## **STAFF REPORT AND RECOMMENDATION TO THE DESIGN COMMISSION**

CASE FILE: LU 20-102914 DZM AD GW (previously 19-225732 DZM GW)  
PC # 19-225732

***Alamo Manhattan Blocks***

REVIEW BY: Design Commission

LAND USE REVIEW # (LU-20-102914 DZM GW) EXHIBIT C.103

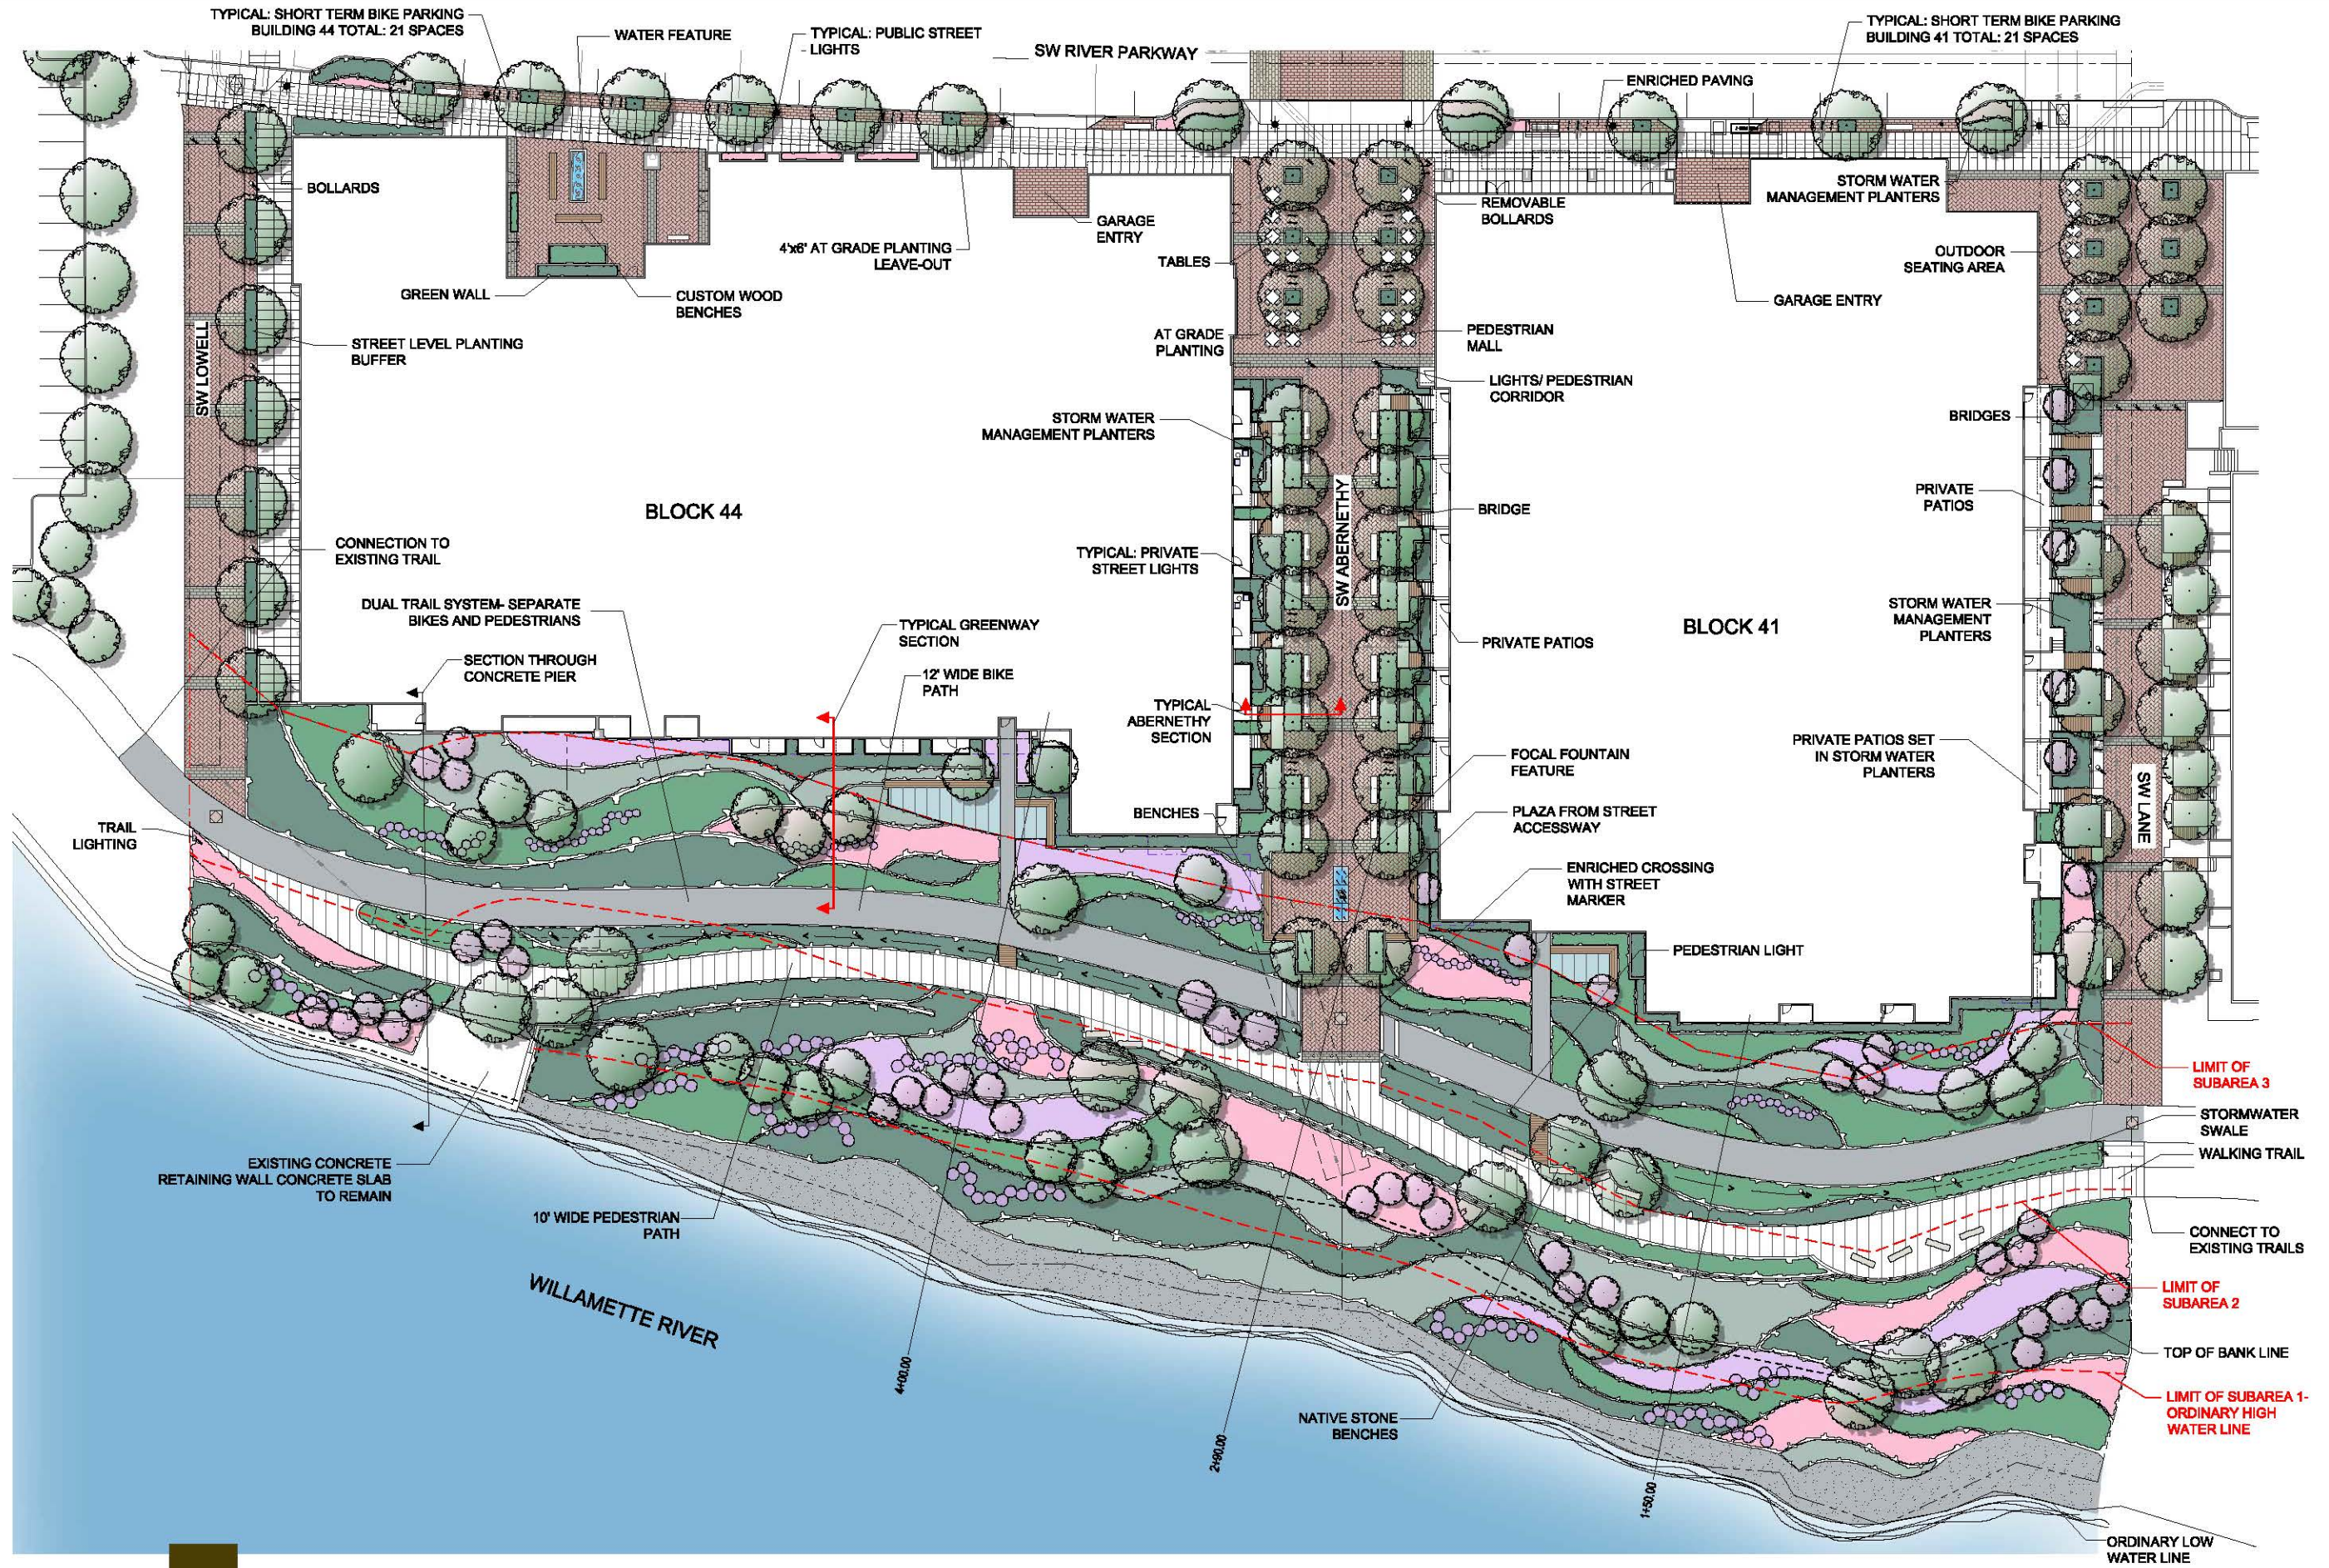
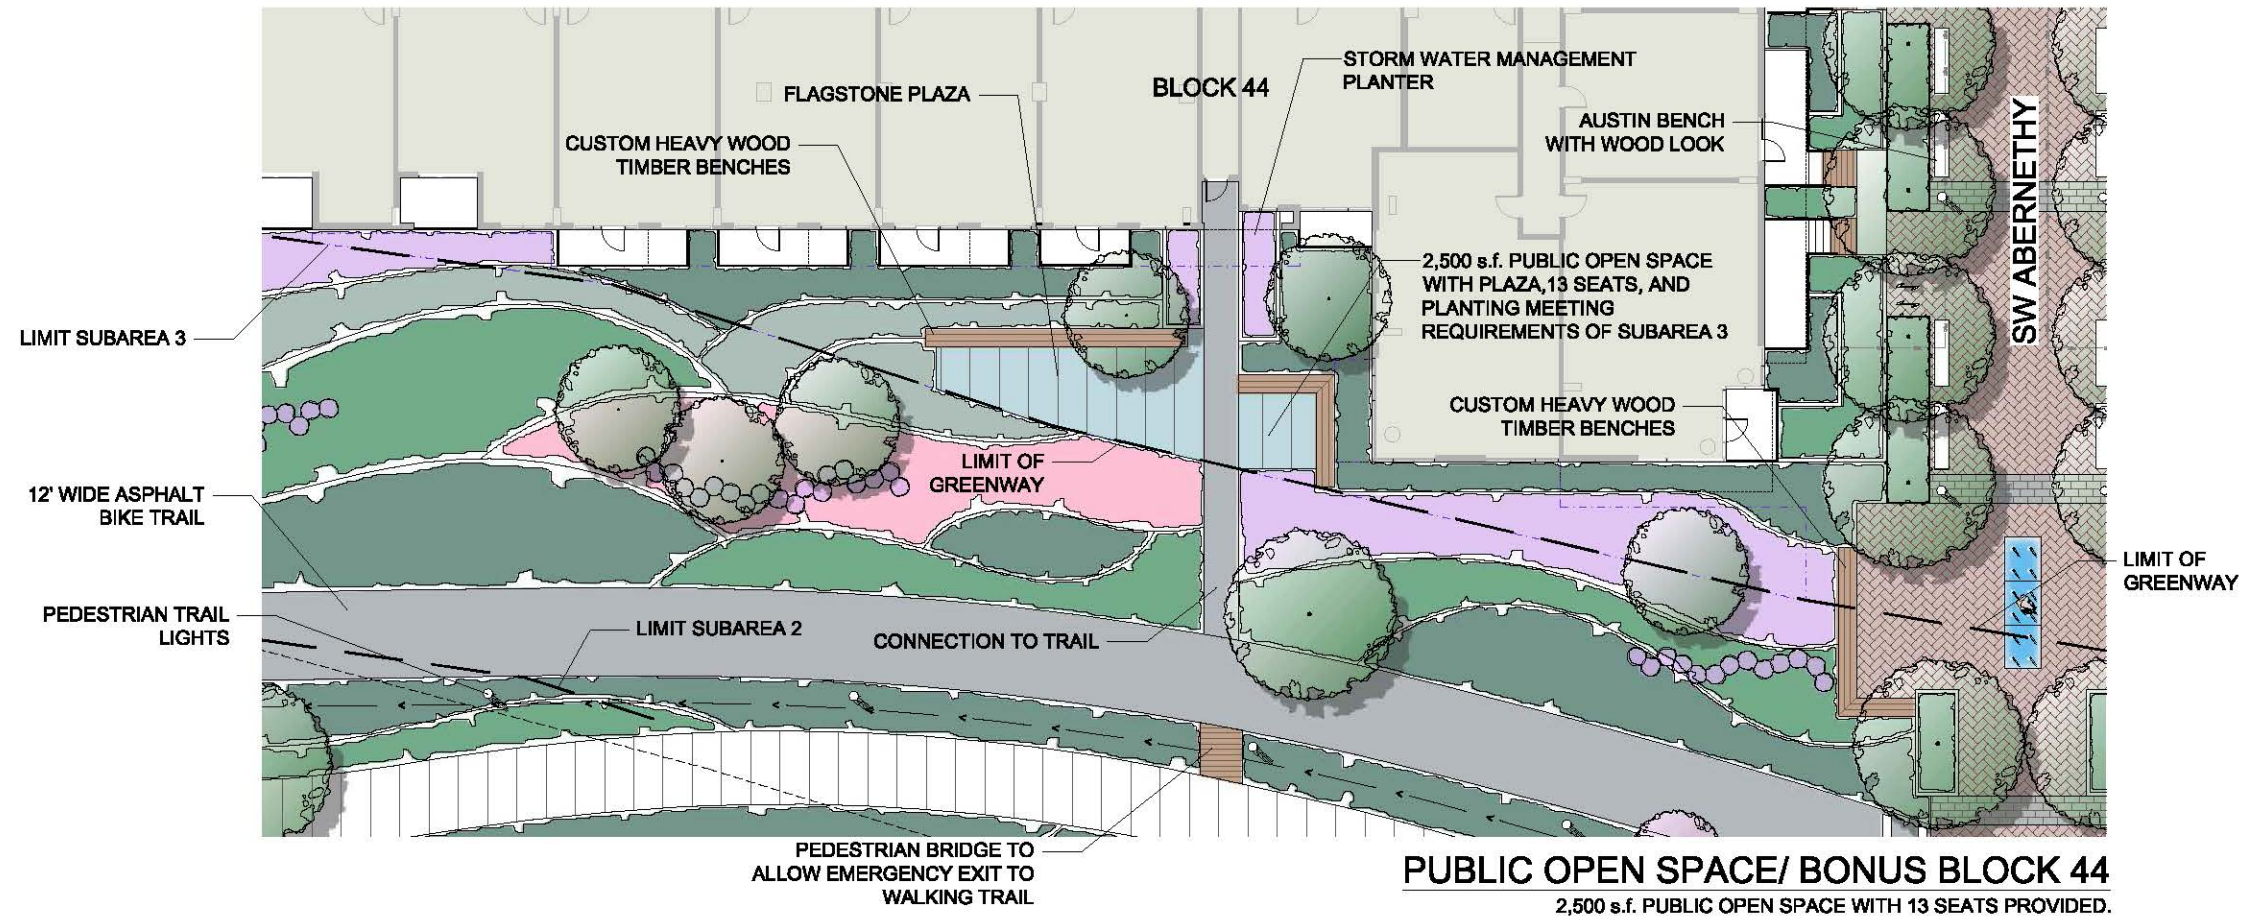
The applicant’s Exhibit C.106 depicts proposed fencing, planter materials, timber and basalt benches, and piers to be used in the Greenway to integrate art and found objects, and to provide historical context. More detail would be useful in the form of dimensioned detail drawings to inform reviewers as to the specific placement and constructability of these features.
